## Determination 2018/021

# The refusal to issue a building consent for a house with membrane roofs at 25 Oceanbeach Road, Mount Maunganui, Tauranga

Figure 1: Section through length of house

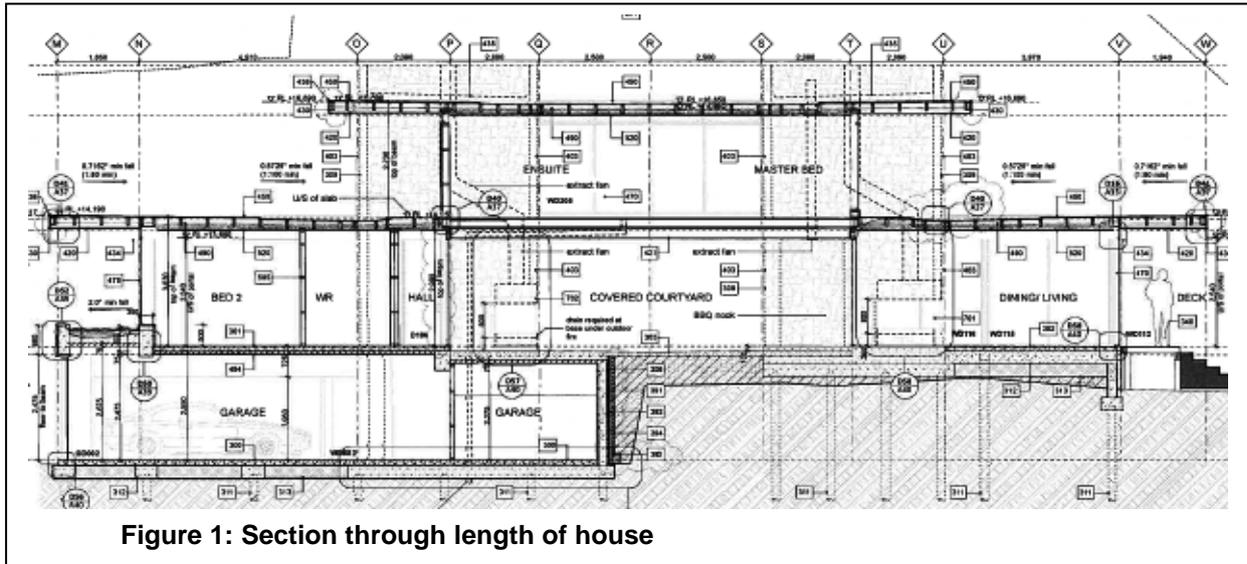
- 2.1 The proposed building work consists of a 2-storey detached house with a basement as shown in Figure 1. The house is situated on a long and narrow coastal site in a very high wind and sea spray zone for the purposes of NZS 3604<sup>6</sup>. The site is 'near level', with an excavated basement garage at the western end. The drawings take the garage doors as facing west and this determination follows that convention.
- 2.2 Construction is generally light timber frame, with specifically designed steel portals, concrete slabs, driven pile footings, and reinforced concrete block foundations and retaining walls. The house has vertical cedar shiplap weatherboards fixed over a cavity, aluminium joinery, a two-level membrane roof and two stone-clad reinforced concrete 'chimney' structures that also serve as ducts for downpipes.

**Figure 2: Roof plan**

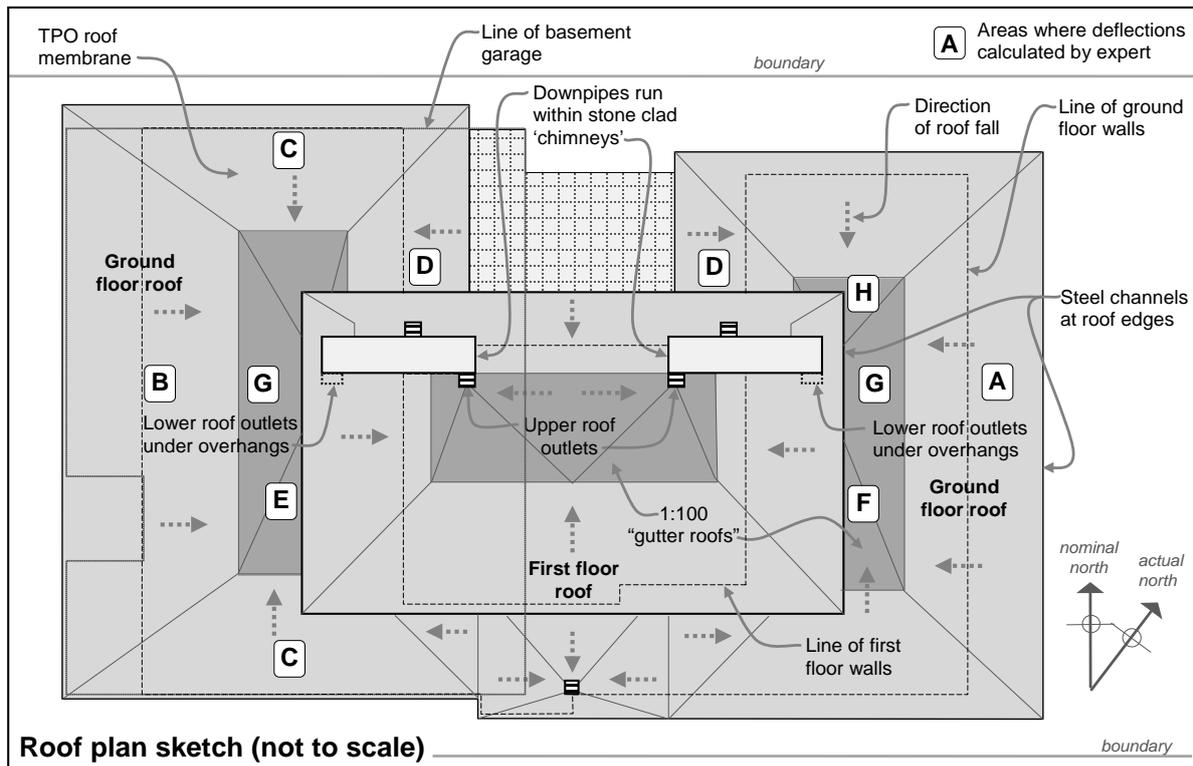
- 2.3.1 The drawings call for roofs to fall at a minimum slope of 1:80 towards large near-flat central areas ("the gutter roofs") that fall at 1:100 towards drainage outlets, with downpipes taken down the two service ducts as shown in Figure 2. The architect has advised the expert that roof falls will be increased to 1:66 'to allow for settlement and construction tolerances and ensure the finished fall is equal to or greater than 1:80' (see paragraph 5.2.2).

5.3.2 Because the asymmetric roof geometry results in varying slopes on different membrane sections, the expert calculated slopes as shown in Table 1 at 4 roof and 4 gutter roof locations (see Figure 2), based on stated levels for the ground floor roof:

- Area E (see Table 1) has the lowest slope at 1:110
- the specification calls for a minimum slope of 1:100
- relative levels of Area E will need adjusting to achieve the above slope.

- drawings are revised to show increase in slope
- Area E (see Figure 2) is adjusted to achieve gutter roof slope of 1:100
- drawings to confirm that structural steel at roof edges will incorporate 10mm pre-camber.
